## Transitioning designs from the THAT 4301 to the THAT 4305

While it is unfortunate that the 4301 will be leaving us, replacing the 4301 in existing designs with the 4305 (and three discrete op amps) is relatively straightforward and can result in a design of equal or better performance in the same amount of PCB real estate, at a reduced cost. Hopefully this guideline will help to ease the transition.

**What about PC real estate?**

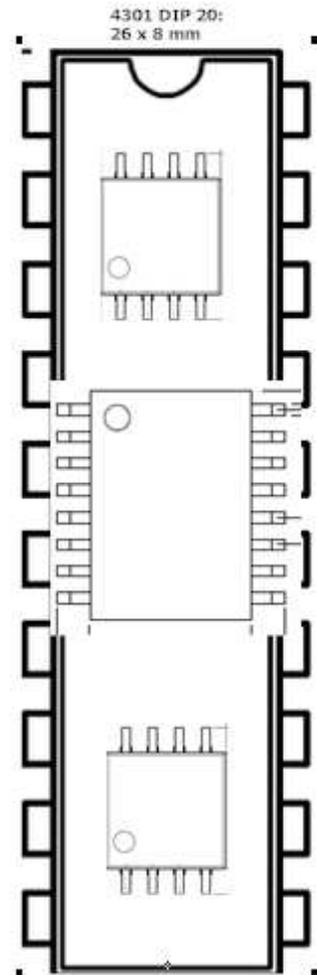
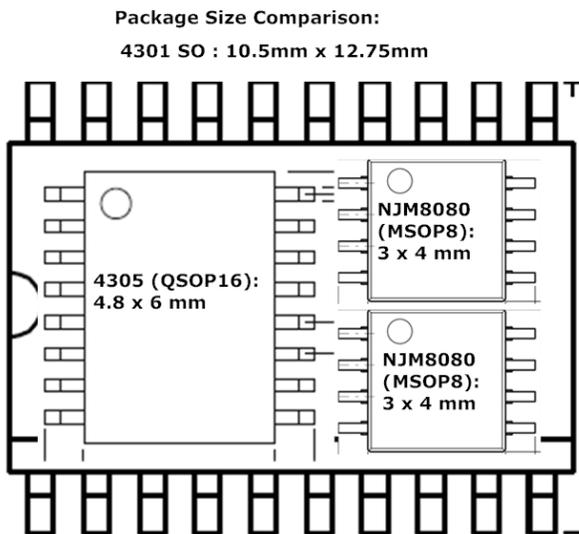
The new design should take up no more PC area if small package op amps are used. Here is a quick sketch showing the approximate package sizes relative to each other. Please keep in mind that this is not a precision scaled drawing is presented only to give the PC designer a feel for required size. Also note that the op amps are in duals, so there is an extra op amp section available for use elsewhere in the design.

### Example compressor/limiter design transition to the 4305

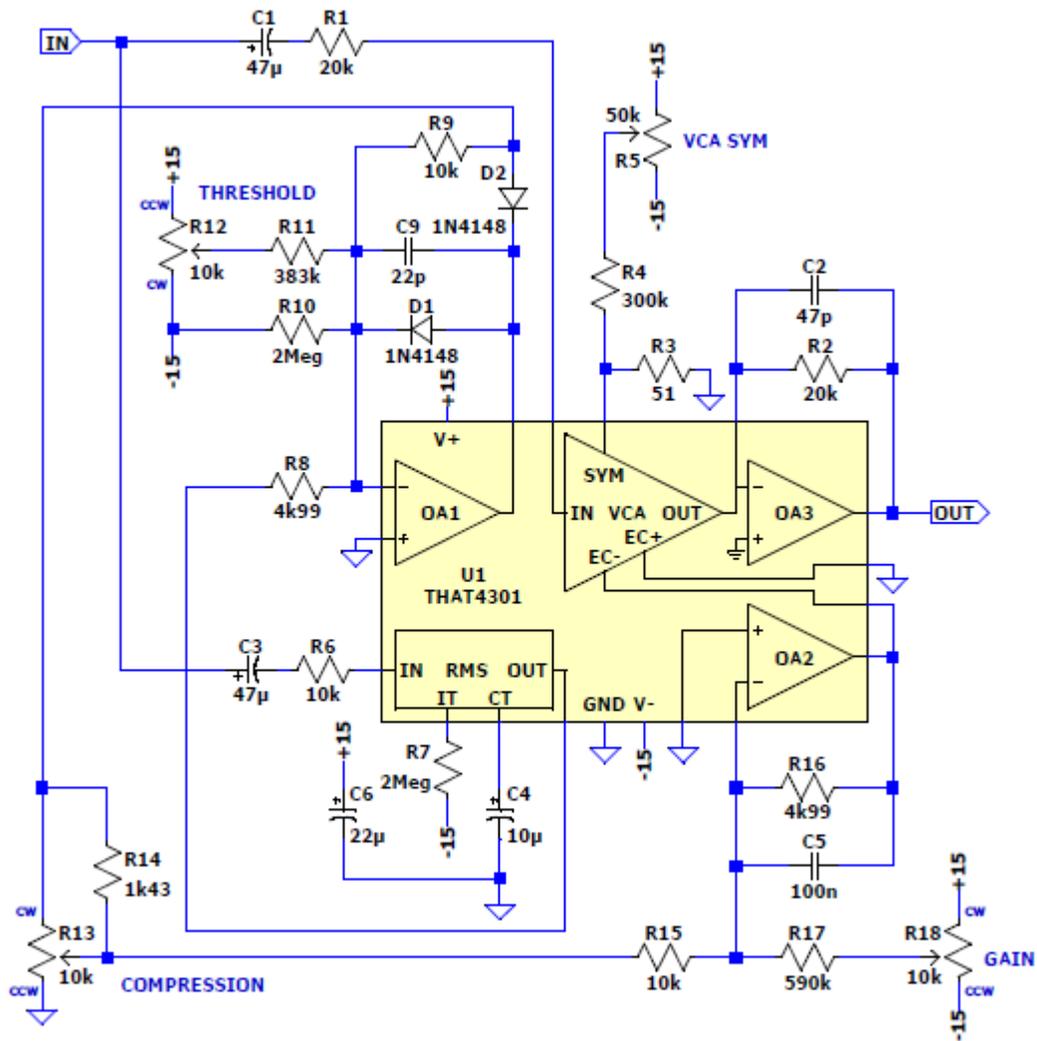
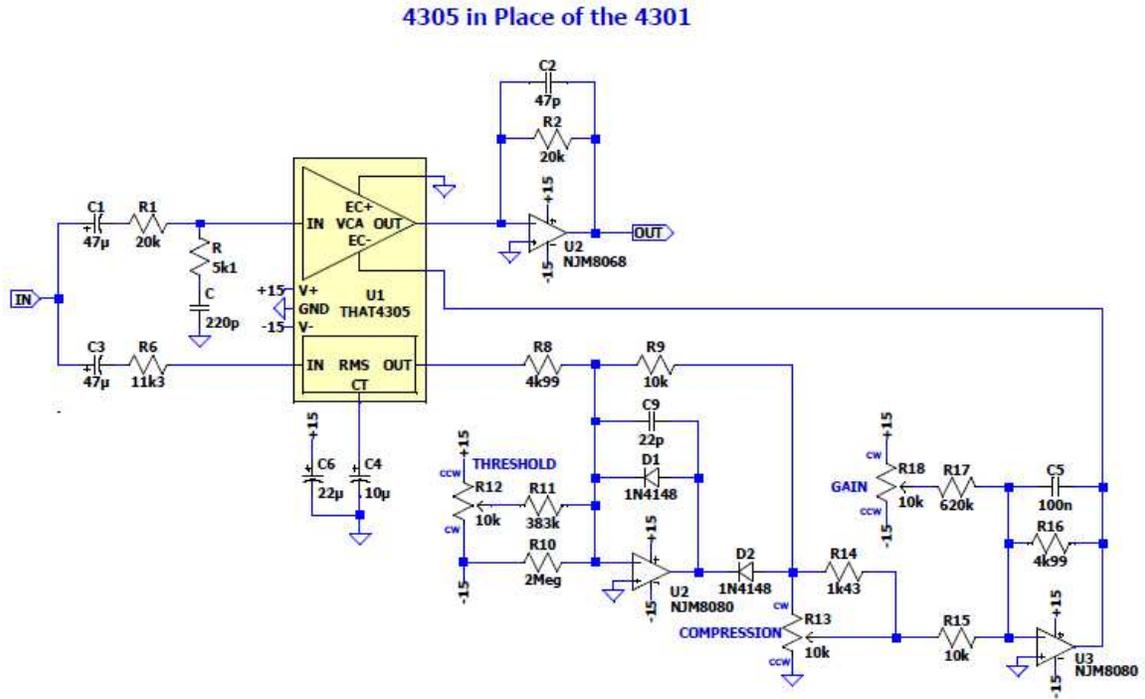
This is the original design, based on the application circuit presented in the 4301 data sheet:

This is the new design using the 4305 and three external op amps:

The “0 dB Reference” current is defined as the magnitude of the RMS detector’s input current required to produce 0.0V at the RMS detector’s output. The 4305 RMS requires 7.5uA in order to achieve this 0dB point, while the 4301 requires 8.48uA. As a result, the input resistor feeding the 4305’s RMS detector should be made 1.13 times larger ( $8.48\mu\text{A}/7.5\mu\text{A}$ ) than the one used in the original 4301 design. Although the error would be quite small, scaling the 4305’s RMS input resistor by 1.13 will insure precise matching to any of the previous design’s front panel threshold calibration markings.

The 4305 VCA is trimmed internally during the manufacturing process and any symmetry trim components can be removed when transitioning to the 4305.

The 4305 VCA should be compensated with an R-C network connected between the VCA’s input pin and local ground. Using a 5k1 resistor and a 220pF will insure that the VCA remains unconditionally stable.

The gain control constant is 6.2mV/dB for the 4305 and is 6.5mV/dB for the 4301. This difference is typically transparent in most applications since the VCA’s sensitivity is perfectly matched to RMS scaling in both the 4305 and the 4301. In a compressor limiter application, this means that infinite compression will still be infinite compression in the new 4305 design without changing any scaling in the CV processing chain.
